ADDENDUM #1

PROJECT: South Texas College Pecan Campus

BUILDING H RENOVATION FOR CULINARY ARTS

RFP #19-20-1008

ENLARGED FLOOR PLAN: PLUMBING
SCALE: 1/4" = 1'-0"

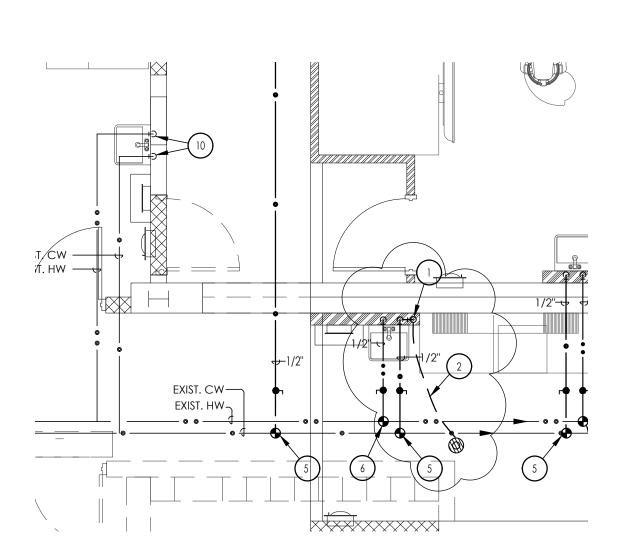
- A. Sheet P2.0 Add new floor drain. Refer to attachment.
- B. Sheet P3.0 Add new trap primer to new floor drain. Refer to attachment.
- VI. Fire Protection: N/A
